Final Environmental Impact Statement Talapoosa Mining Inc.'s Talapoosa Mine Project

**FINAL ENVIRONMENTAL IMPACT STATEMENT
TALAPOOSA MINE PROJECT
LYON COUNTY, NEVADA**

This Final Environmental Impact Statement (FEIS) responds to comments received during the public comment period on the Draft Environmental Impact Statement (DEIS), which analyzed impacts due to the proposed development of an open-pit gold and silver mining operation (the Talapoosa Project). The operation, with an expected mine life of seven to ten years, would include a 118-acre open-pit mine and two smaller pits (7 and 22 acres respectively), overburden and interburden disposal areas, ore stockpiles, a valley fill leach pad, process solution ponds, a processing plant, water treatment and supply facilities, administration and support facilities, and necessary ancillary facilities. Approximately 596 acres would be disturbed. Access would be provided by upgrading an existing road from U.S. Highway 95 Alternate. Two miles of new road construction are being proposed on the steeper areas and adjacent to the mine site.

FIGURE 4.2

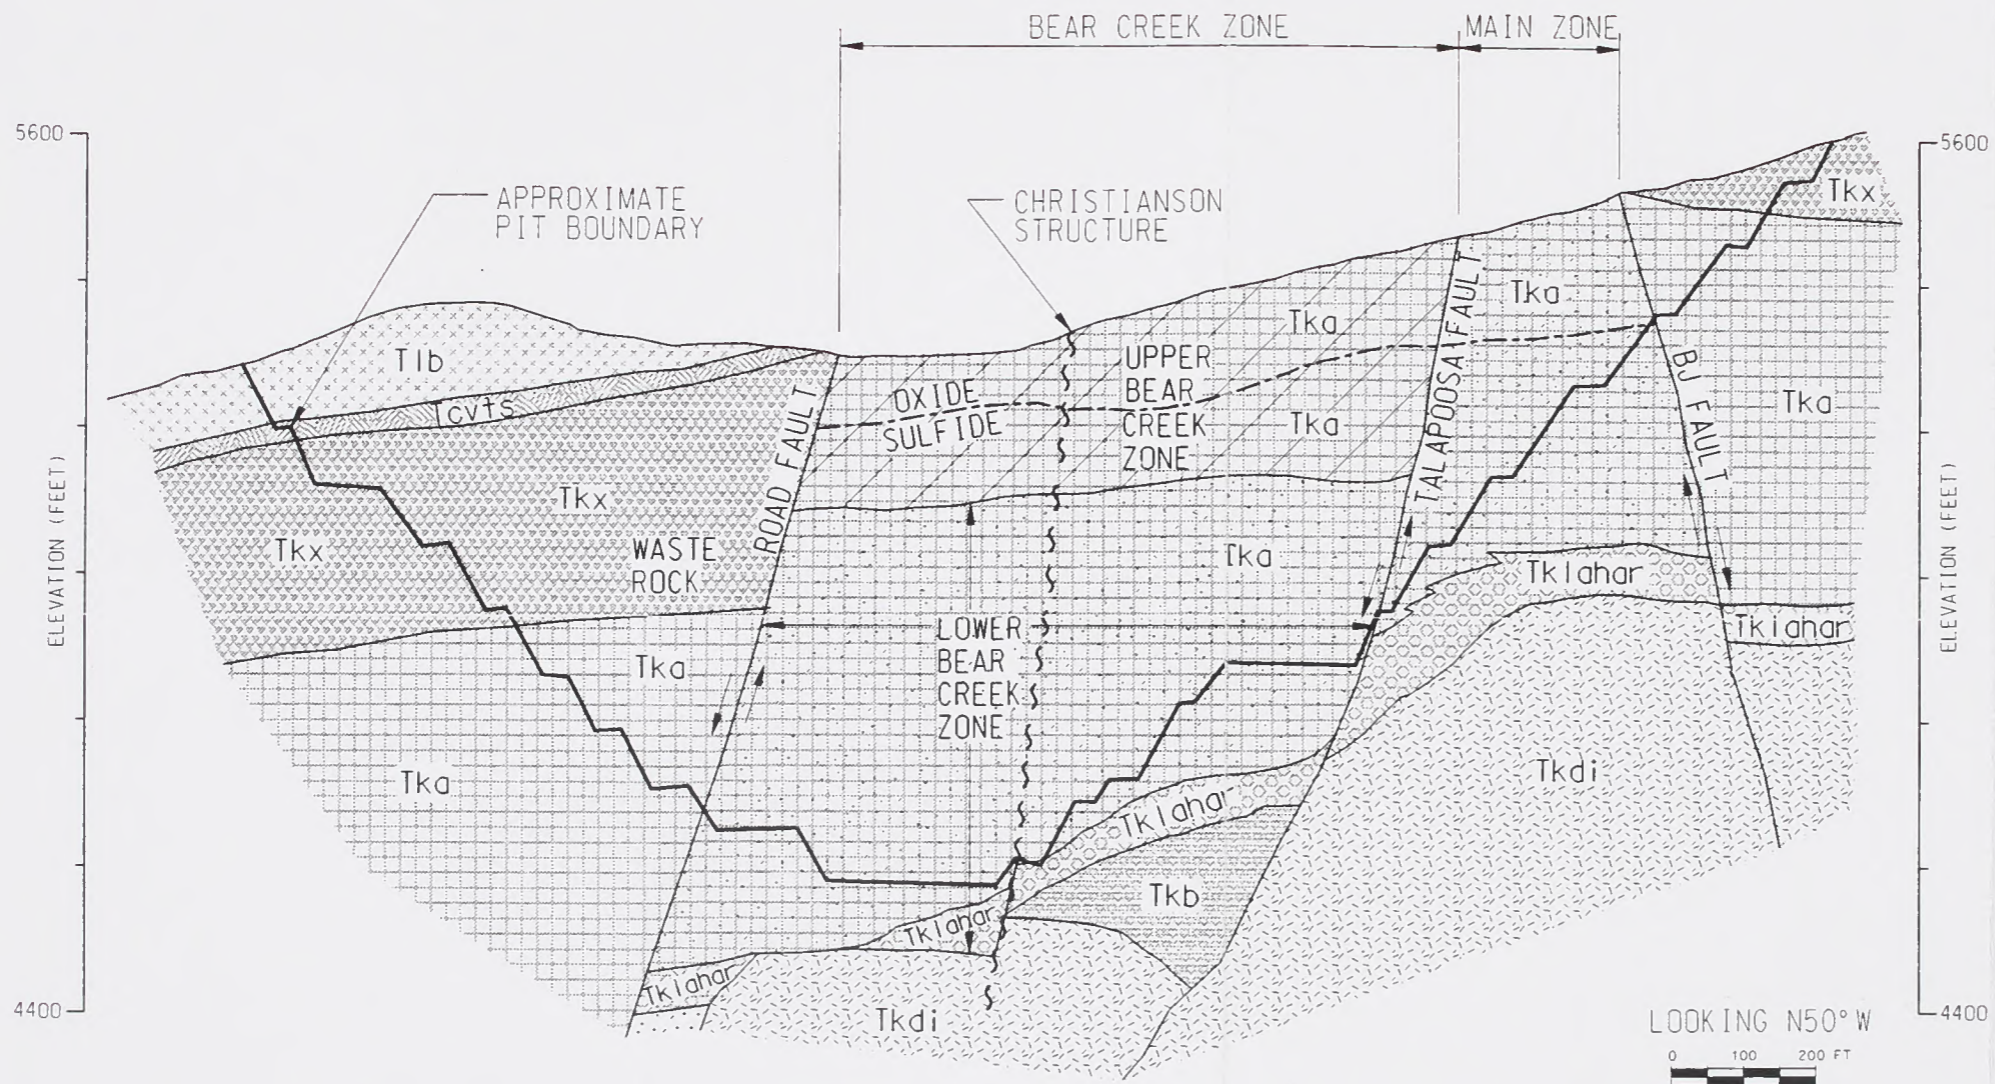
Figure 3.7 of the DEIS refers the reader to Figure 3.10 for the location of cross-section A-A'. A-A' is not depicted on Figure 3.10. The FEIS should rectify this. Figure 3.7 should also provide a compass direction and vertical scale.

[25] The location of section A-A' is shown on figure 3.8, not 3.10 as stated. Figure 3.10 depicts the waters of the United States.

Figure 3.7, Geologic Cross Section A map has been corrected. See FEIS Figure 4.2 for the corrected map. Cross Section A-A' referenced on Figure 3.7 is found on DEIS Figure 3.8 and FEIS Figure 4.3.
